Application Number	
Filing Date	02-Oct-2014
First Named Inventor	Peter John COUSINS
Title	FRONT CONTACT SOLAR CELL WITH FORMED EMITTER
Art Unit	
Examiner Name	
Attorney Docket Number	10031.004211

Petitioner Canadian Solar Inc. - Ex. 1005, p. 20

FIG. 3D

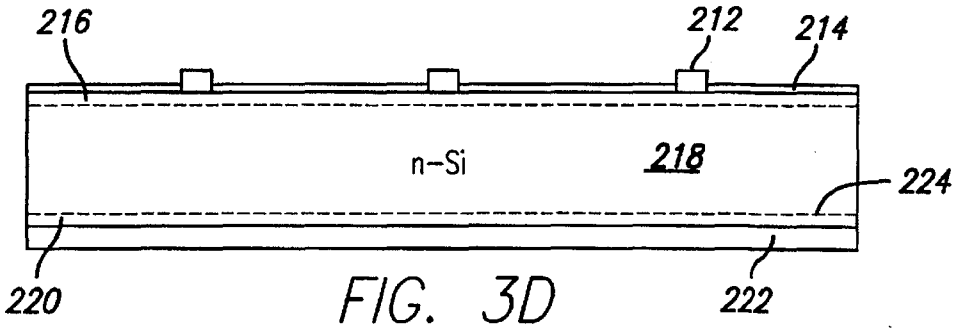
The final office action suggests that in the cited combination, Meier discloses the recited backside junction. Meier FIG. 3D is reproduced below for ease of discussion.

Meier discloses a solar cell with an aluminum alloy back junction (Meier, Title). More specifically, Meier discloses forming a p+ layer 220 ("emitter") that forms a backside junction with the n-Si base layer 218 ("substrate") within the base layer 218 by doping using the aluminum contact layer 222 (Meier, col. 6, lines 51-54). That is, the main

FIG. 3D

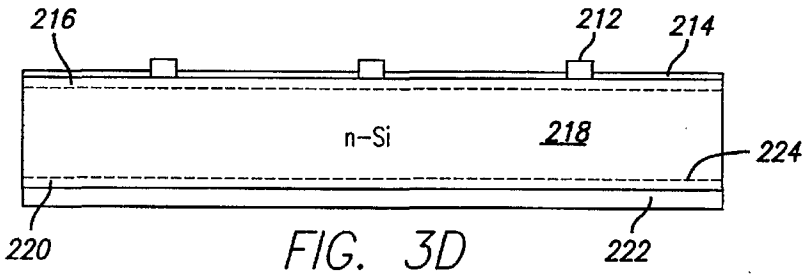
The final office action suggests that in the cited combination, Meier discloses the recited backside junction. Meier FIG. 3D is reproduced below for ease of discussion.

Meier discloses a solar cell with an aluminum alloy back junction (Meier, Title). More specifically, Meier discloses forming a p+ layer 220 ("emitter") that forms a backside junction with the n-Si base layer 218 ("substrate") within the base layer 218 by doping using the aluminum contact layer 222 (Meier, col. 6, lines 51-54). That is, the primary teaching of Meier is to form an aluminum alloy back junction by forming the p+ layer 220 within the substrate by diffusion into the substrate using the aluminum alloy electrode, thereby providing a strongly doped p-type emitter (Meier, abstract).

FIG. 3D

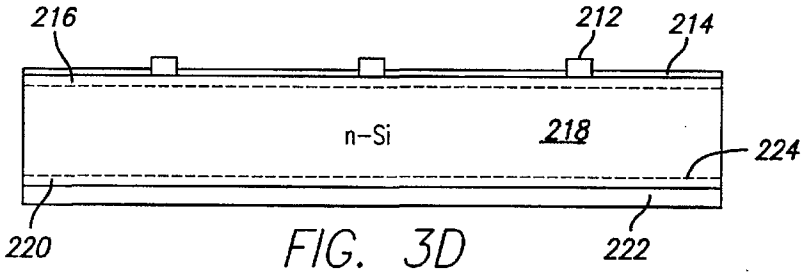
The final office action suggests that in the cited combination, Meier discloses the recited backside junction. Meier FIG. 3D is reproduced below for ease of discussion.

Meier discloses a solar cell with an aluminum alloy back junction (Meier, Title). More specifically, Meier discloses forming a p+ layer 220 that forms a backside junction with the n-Si base layer 218, within the base layer 218, by doping using the aluminum contact layer 222 (Meier, col. 6, lines 51-54). That is, the primary teaching of Meier is to form an aluminum alloy back junction by forming the p+ layer 220 by diffusion into the

FIG. 3D

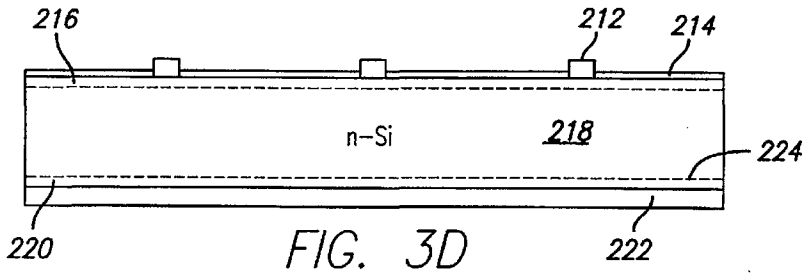
The final office action suggests that in the cited combination, Meier discloses the recited backside junction. Meier FIG. 3D is reproduced below for ease of discussion.

Meier discloses a solar cell with an aluminum alloy back junction (Meier, Title). More specifically, Meier discloses forming a p+ layer 220 that forms a backside junction with the n-Si base layer 218, within the base layer 218, by doping using the aluminum contact layer 222 (Meier, col. 6, lines 51-54). That is, the primary teaching of Meier is to form an aluminum alloy back junction by forming the p+ layer 220 by diffusion into the substrate using the aluminum alloy electrode, thereby providing a strongly doped p-type emitter (Meier, abstract).

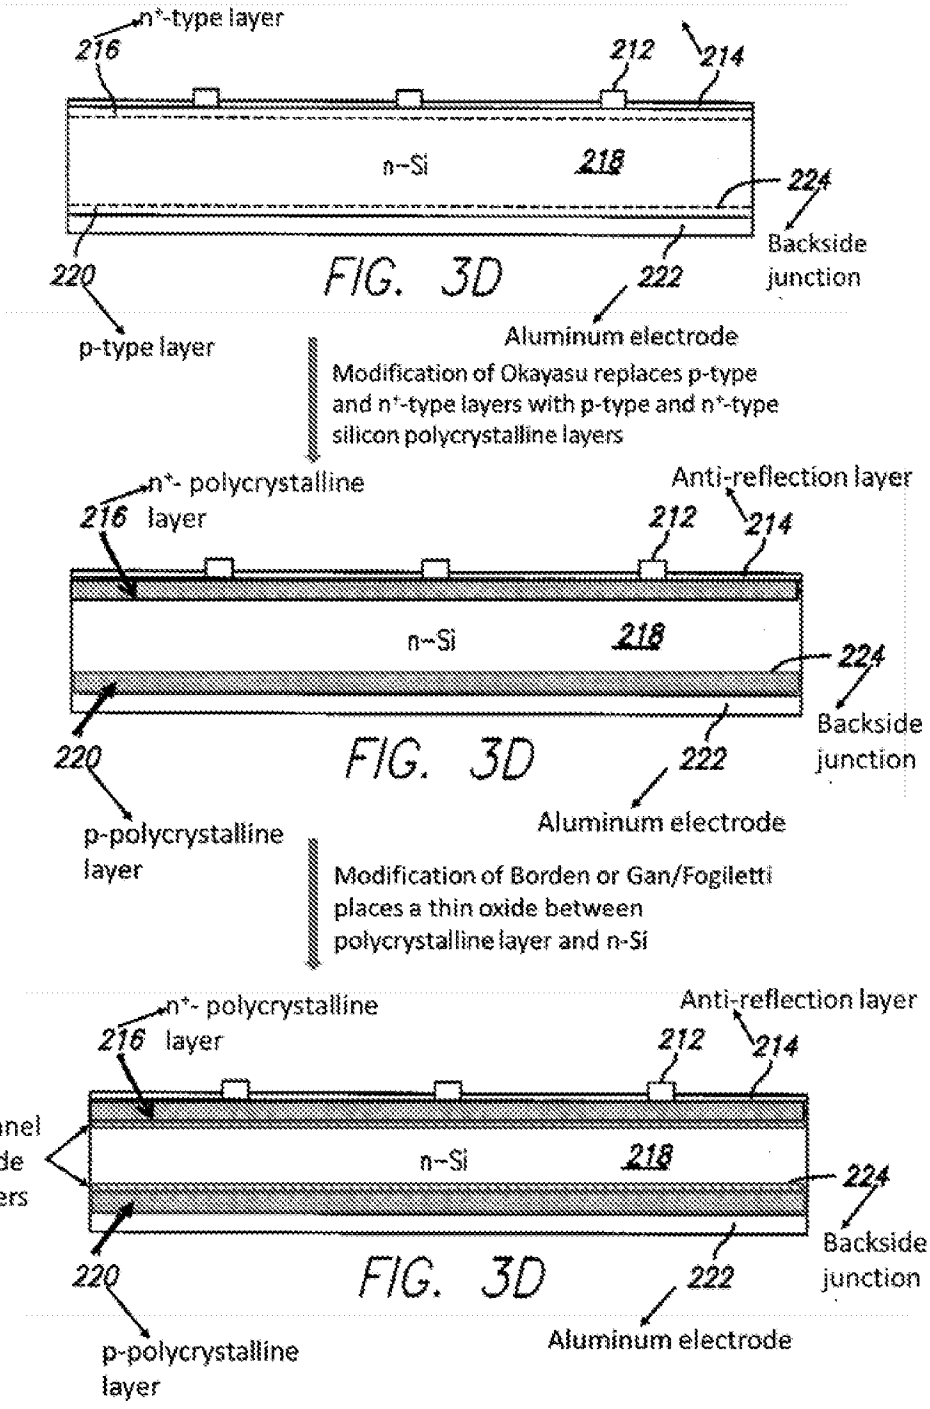
Appellant argues with respect to claim 1 that while Meier discloses a backside junction formed between the emitter (220) and base (228) Meier does not disclose the tunnel oxide between the base and emitter. Furthermore, if there were a tunnel oxide present in Meier the formation of the emitter would not be possible since it is formed from diffusion with the contact layer (222).

Appellant further argues that Okayasu discloses a BSF solar cell and that a BSF layer cannot form a backside junction with the substrate and therefore the combination of Meier and Okayasu is not possible.

FIG. 3D

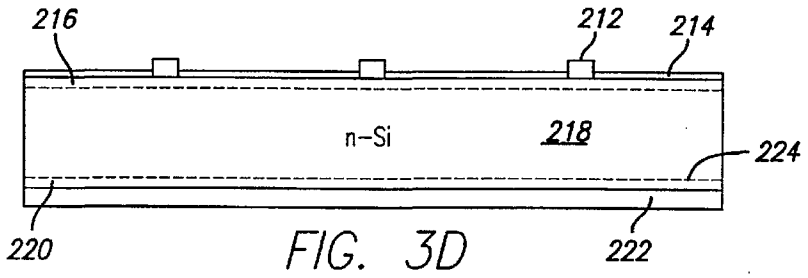
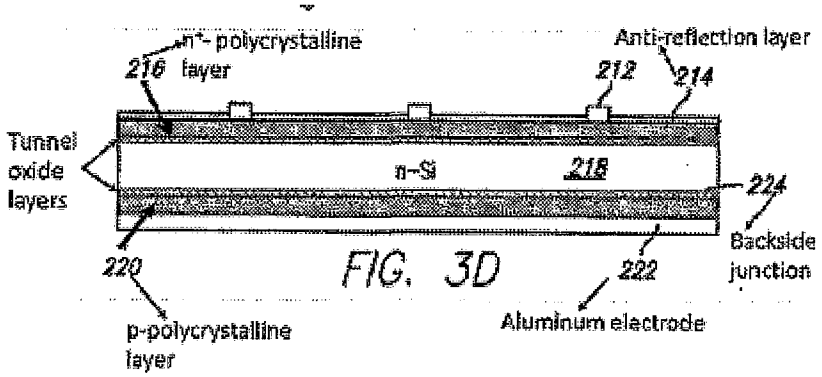
The drawing on page 10 of the Examiner's Answer shows the extent of the proposed modification to Meier. Comparing Meir's original structure,

to the modified structure,

one can see immediate major differences.

FIG. 3D

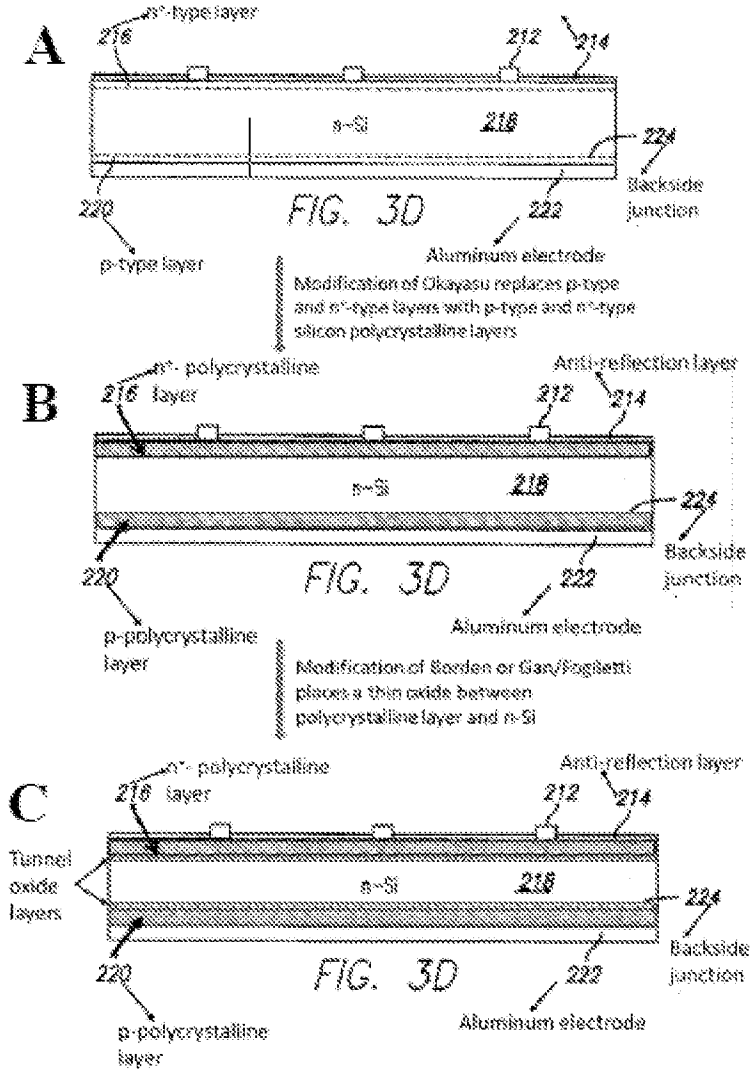
Ans. 10.
